AGENDA FOR REGULAR MEETING VILLAGE OF TINLEY PARK PLAN COMMISSION

April 20, 2017 – 7:30 P.M. Council Chambers Village Hall – 16250 S. Oak Park Avenue

PLAN COMMISSION STAFF REPORT

PLAN COMMISSION STAFF REPORT

Diagram Showing Staff's Recommendations for Sidewalks and Crosswalk

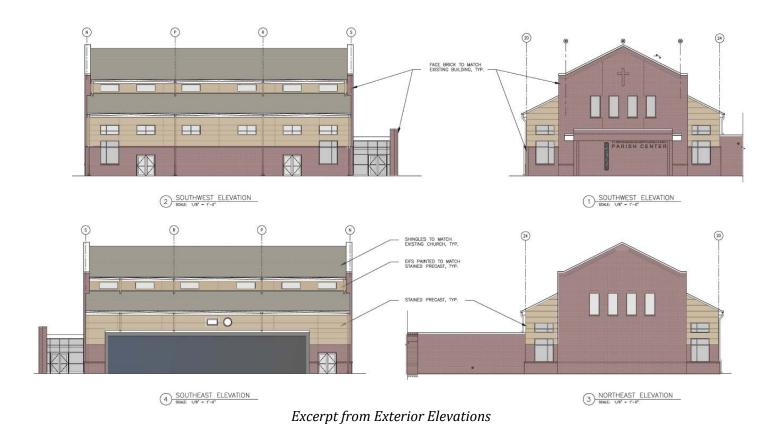
Staff notes that the Applicant is considering an alternate configuration for the entry to the new addition from the parking lot. The Police Department had concerns with the main sidewalk leading into a busy intersection within the parking lot. The Applicant should discuss their plans for the main entry to the proposed addition at the workshop.

Staff noted the safety concerns at the April 6, 2017 Plan Commission meeting and worked with the Applicant to mitigate these concerns. The Applicant is considering recommendations from Staff which improve safe access from vehicle drop-off and from the parking lot areas.

PROPOSED SITE PLAN

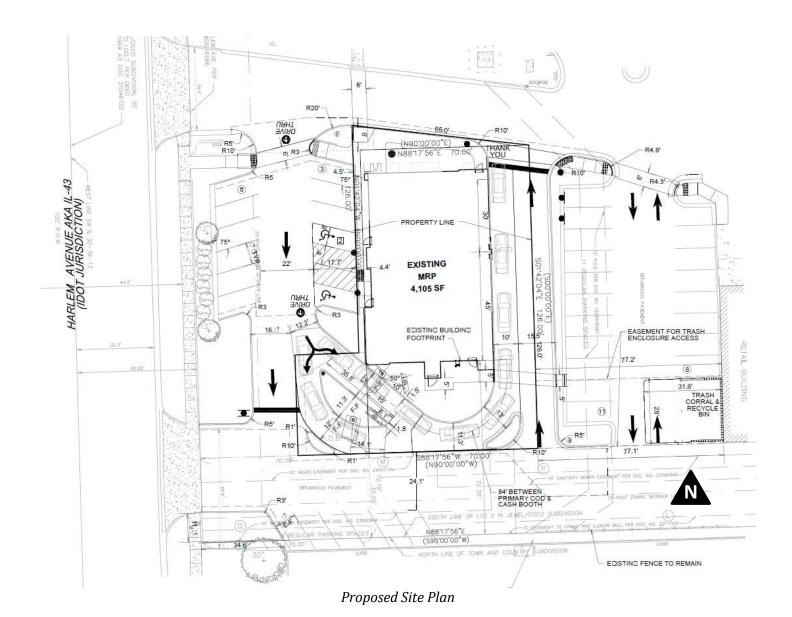
The site currently has 48 parking spaces near the McDonald's site and the proposed plans indicate 36 parking spaces. According to Section VIII.A.10. of the Village's Zoning Ordinance, 21-42 parking spaces are required.

Staff notes that the proposed site plan indicate less than 26' in width for the south drive aisle. This is an existing site, but there are opportunities for achieving the minimum width requirement for this area. Staff has suggested an option in the Open Items section of the Staff Report.

Staff notes that the Applicant proposes to relocate the trash enclosure from the south side of the building near the drive-thru lane to the southeast corner of the adjacent parking lot. Staff supports a relocation of the trash enclosure, which currently negatively impacts drive-thru customers due to its unsightliness and smell. Staff suggests a new location for the trash enclosure, discussed in the Open Items section of the Staff Report.

Excerpts from Color Elevations

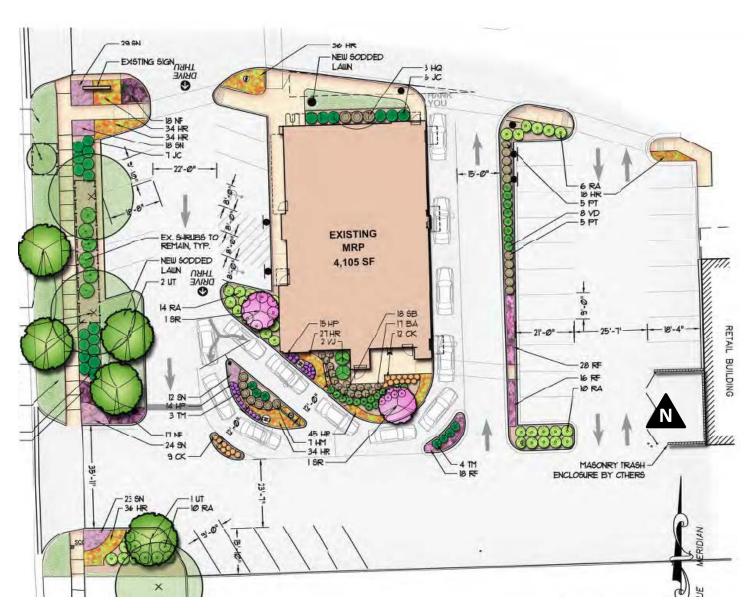
The Applicant provided color renderings that show 89% brick/stone and 11% metal on the exterior elevations. Per the Village's Building Code (Section 305.B.6.a.ii.) "Buildings measuring 3,001- 40,000 square feet should be constructed with a minimum of 75% of exterior materials being face brick with the remaining balance of materials being masonry." Staff notes that the rooftop HVAC units will be adequately screened (see HVAC shown in dashed lines on the elevations below). The elevations also include yellow arches as architectural features.
